Municipal Planning Commission Meeting
Thursday, September 17, 2026 at **6:00 PM**

AGENDA

REPORT TO THE MUNICIPAL PLANNING COMMISSION

SITE LAYOUT PLAN

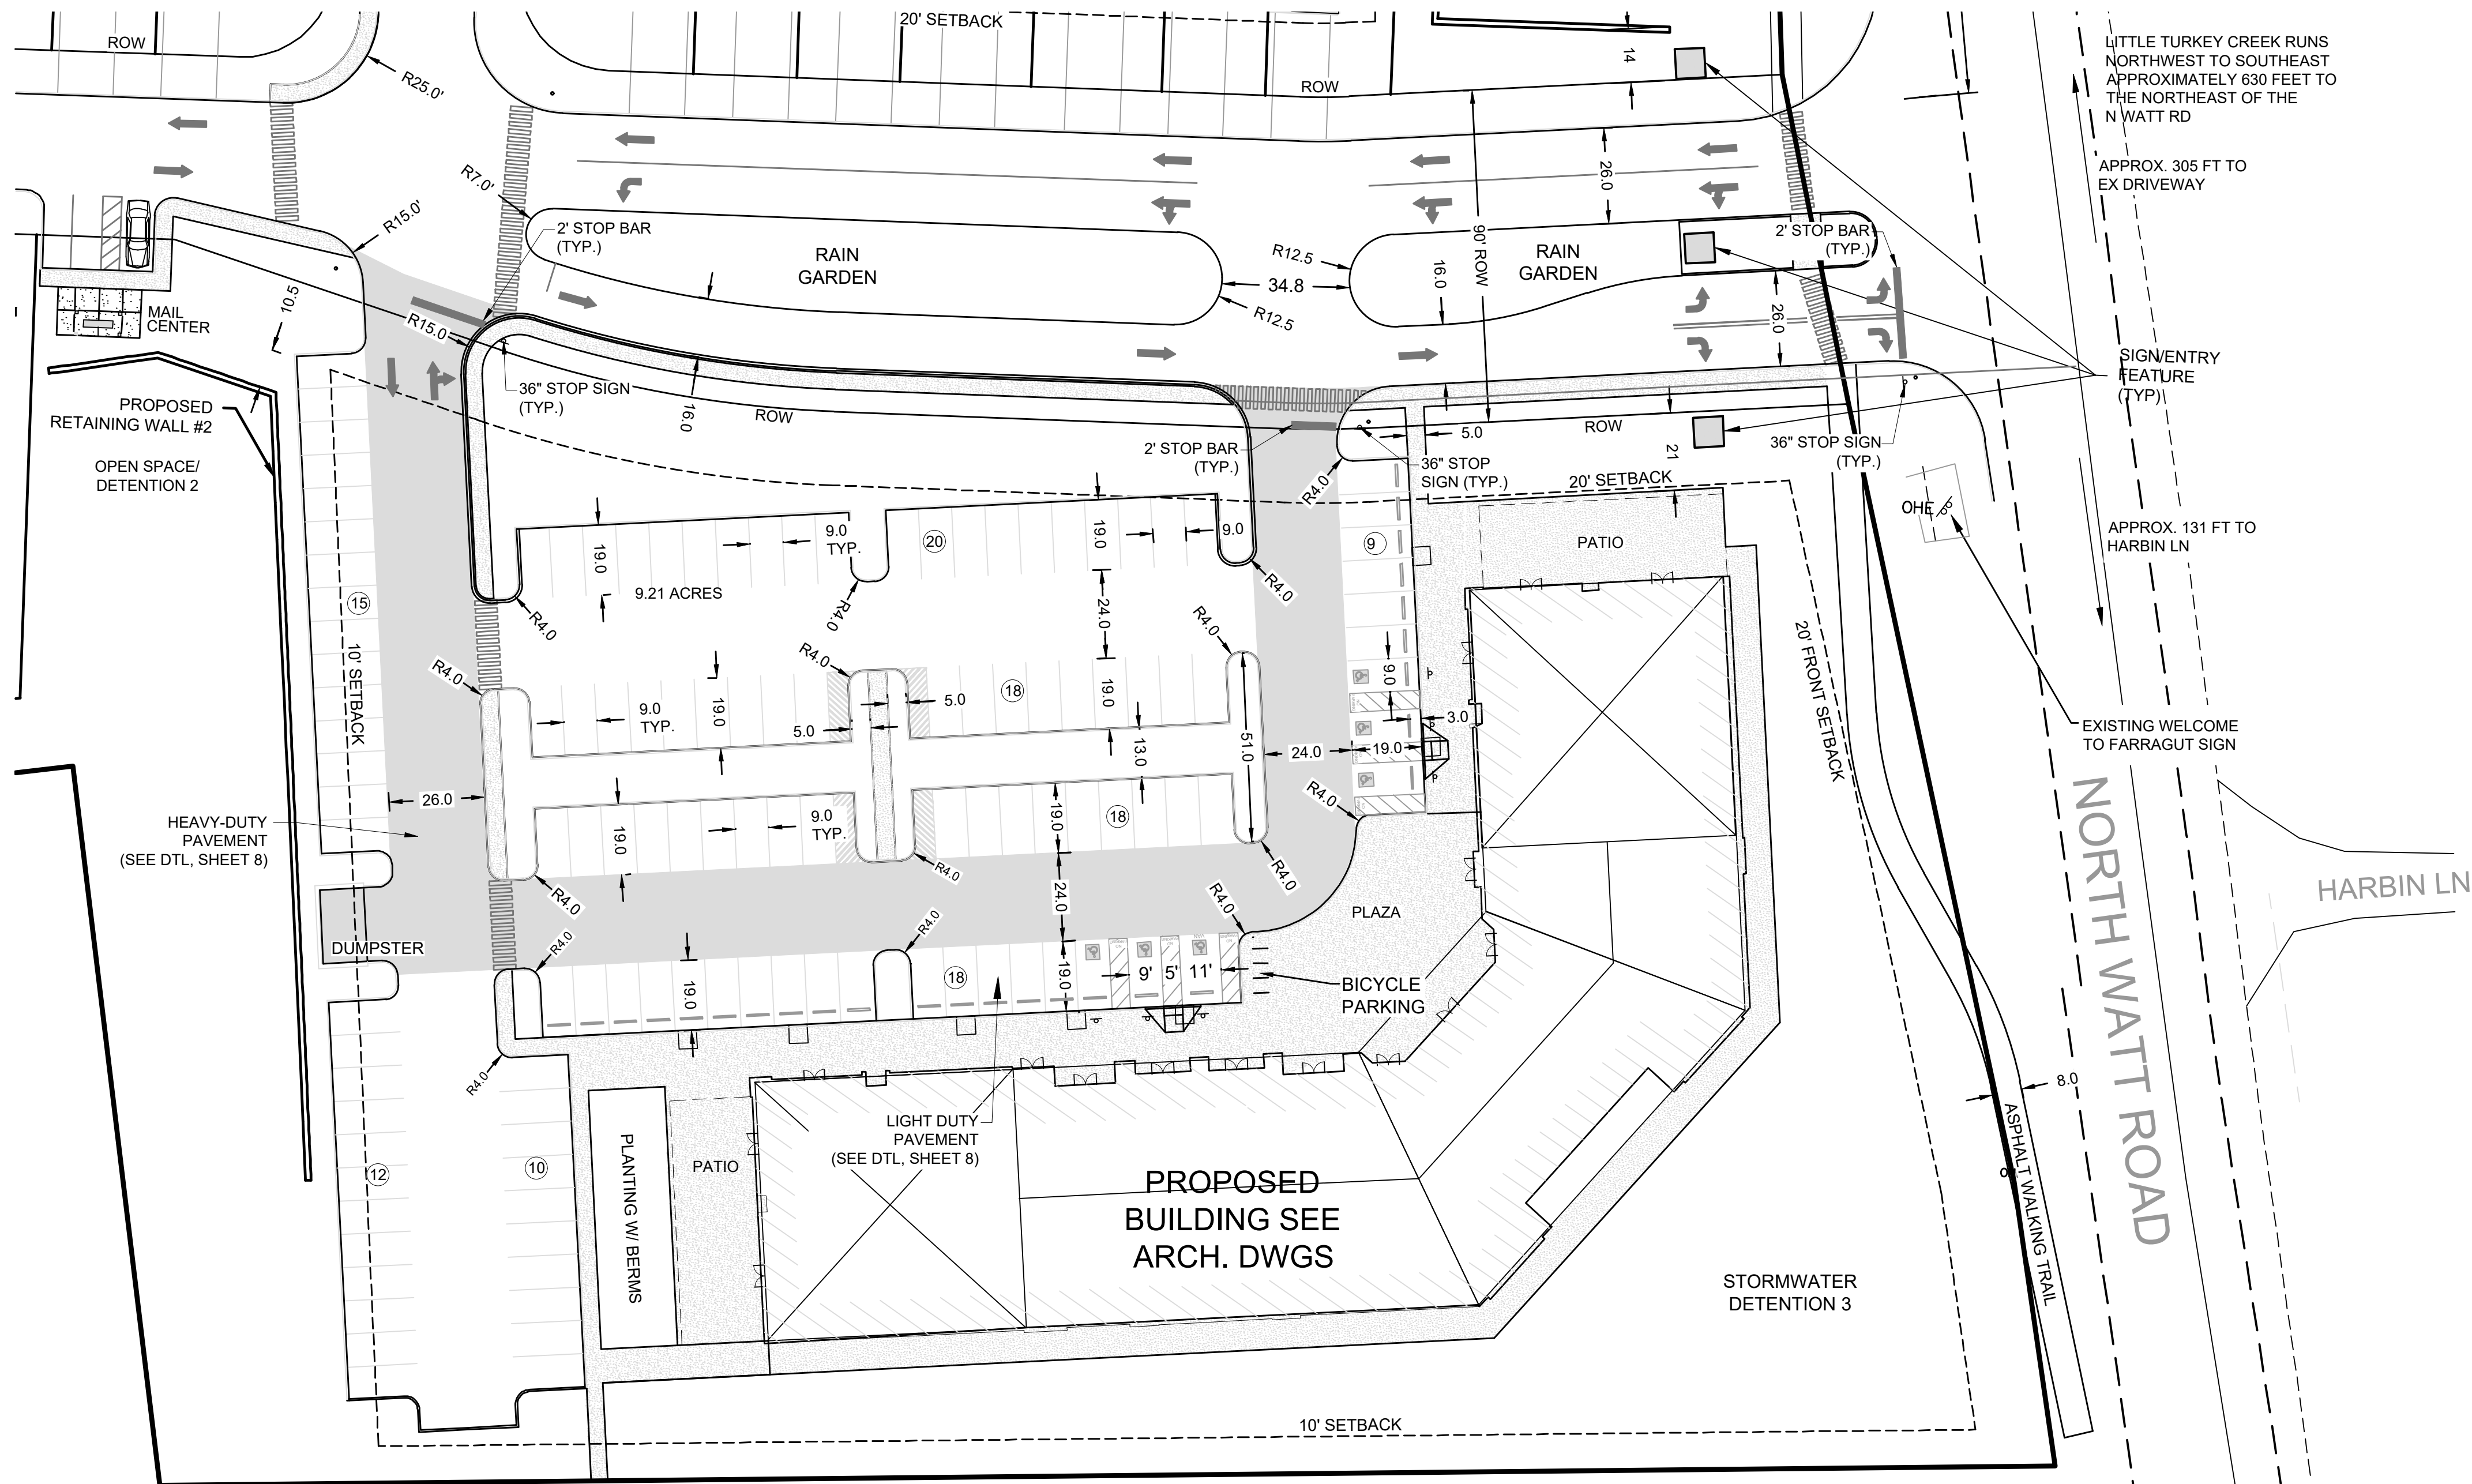
Discussion & Recommendations: The applicant has now submitted a site plan (an initial version is included in the packet) for the commercial portion of the project, but before the plan is presented to the Planning Commission for their approval, the applicant is requesting input from the Planning Commission on the amount of parking that they are proposing. The commercial building is roughly 25,000 square feet and is proposed to have retail and two restaurants. The applicant has allocated parking based on these anticipated uses. Due to the high parking space requirements associated with restaurants, the applicant is 36 parking spaces short of the required amount of parking. For this project, based on the applicant's parking space allocation approach, there are 156 spaces required and 120 spaces provided.

The provisions for increasing or reducing required parking were added to the Zoning Ordinance several years ago to provide more flexibility in parking space requirements and to discourage overparking. From the staff's perspective, a parking deficit of 36 spaces is significant but could be mitigated with restaurants that cater to customers at very different times. For example, a breakfast-oriented café and a dinner-oriented restaurant. Ultimately, this would be managed by the property owner in the selection of tenants.

Another consideration is that, typically, a multiple-use commercial building is classified as a shopping center for parking space requirement purposes because the uses will likely change over time. For a commercial building with less than 50,000 gross square feet, there are five parking spaces required for each 1,000 square feet of gross floor area. If this classification is applied to the applicant's building, there would be 125 parking spaces required. This would result in a deficit of only five parking spaces.
